## 1. Pleasant Street/Hillside Road/Moore Avenue

Figure 3

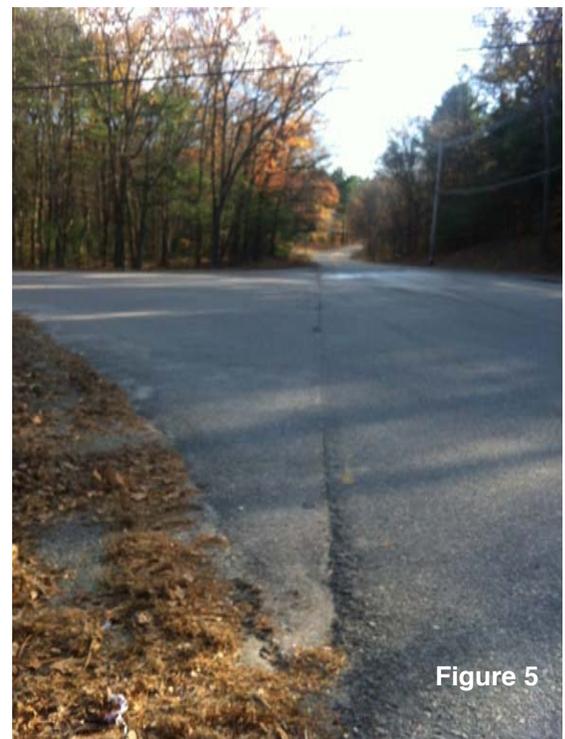
- There are sidewalks but no curbs around this section of Hillside. The asphalt rises gradually up toward the sidewalk. White fog lines could help delineate the roadway edge, which is especially important in low-light conditions or inclement weather. (Figure 3)

Figure 8

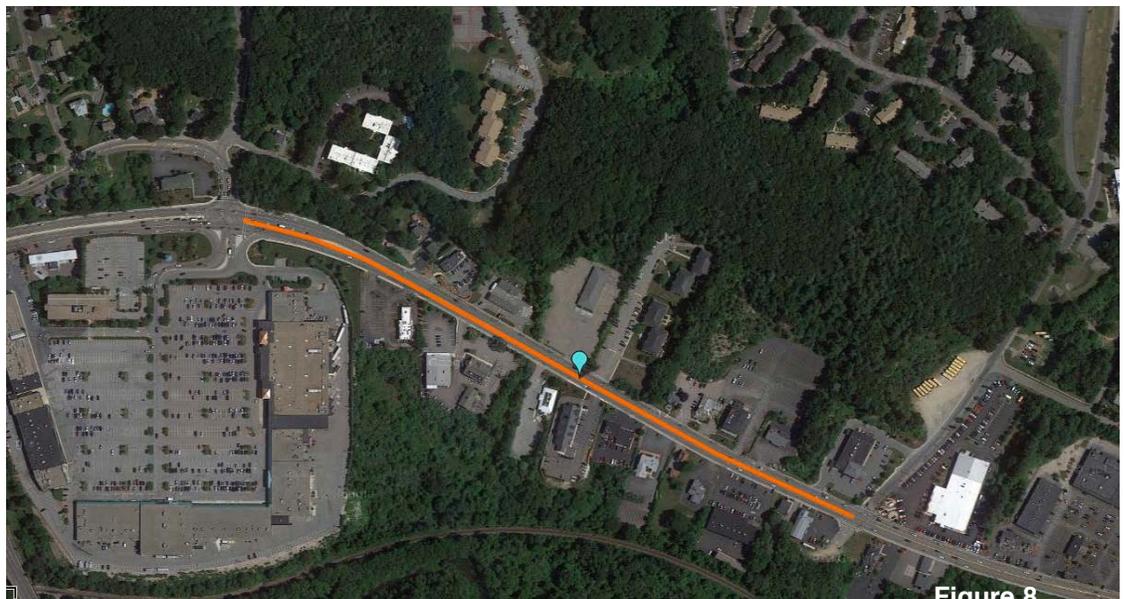
- The distance between marked crosswalks on West Central St (MA Route 140) at Franklin Village Drive and Panther Way is .4 miles. To safely (and legally) cross from one side of W Central to another would require a pedestrian to walk up to .4 miles to access a crosswalk and reach their destination. This section of West Central street has a variety of businesses including a bank, a hardware store, a gas station/convenience store, a Dunkin' Donuts, Subway, and a new Wendy's which appears to generate much of the pedestrian crossings on West Central Street. Figure 8 shows the length between the two crosswalks and a potential location for a new crosswalk. Given the high traffic volumes on West Central Street, a pedestrian-activated HAWK (High-intensity Activated crossWalk) signal would make crossing here much safer than a marked crosswalk alone.
